N5183A-11A

# Information Only Service Note

## N5183A MXG Analog Signal Generator

**The Problem** – The N5180-60024 LCD Assembly is No Longer Available

Figure 2 - LED Backlight Driver Board Connection

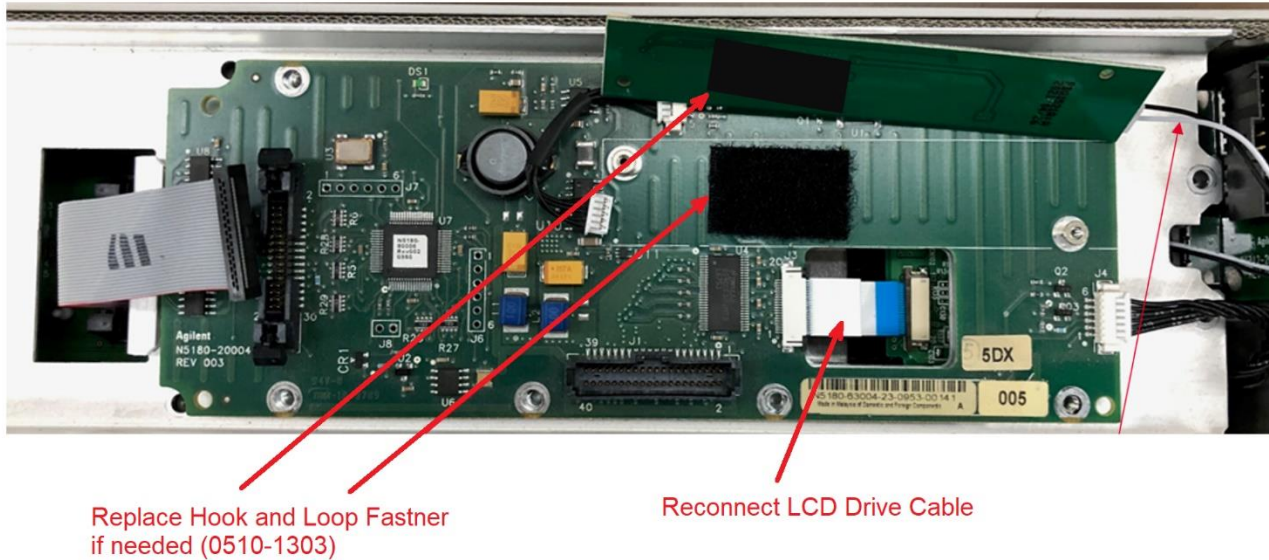
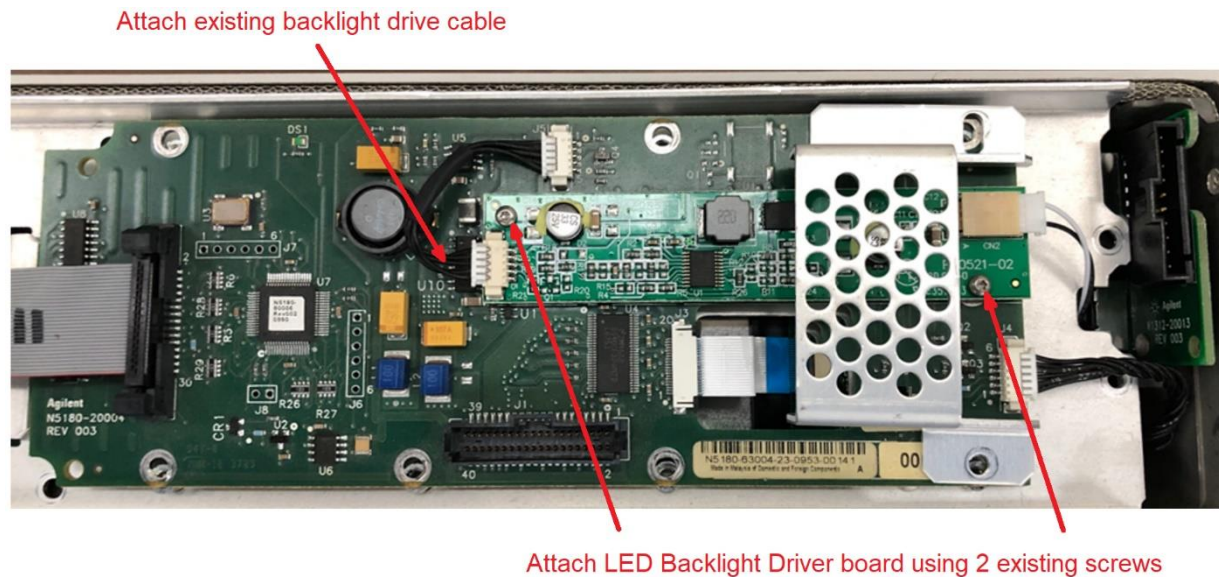
The N5180-69465 replacement LCD assembly will also come with a new backlight driver board. While this will install in the same position as the previous backlight driver board, it is completely different and needs to be used with the rebuilt LCD assembly.

2. Install the replacement LCD into the front frame assembly
3. Install the replacement LED Backlight Driver board using the same location and screws for the original backlight driver board, as shown in Figure 2 and Figure 3

4. Attach the existing backlight drive cable to the new LED backlight driver board, as shown in Figure 3
5. Once the assembly is completed, turn the instrument on and verify operation.
6. If the display needs to be adjusted press **Utility**, **Display** and adjust the **Contrast**, as shown in
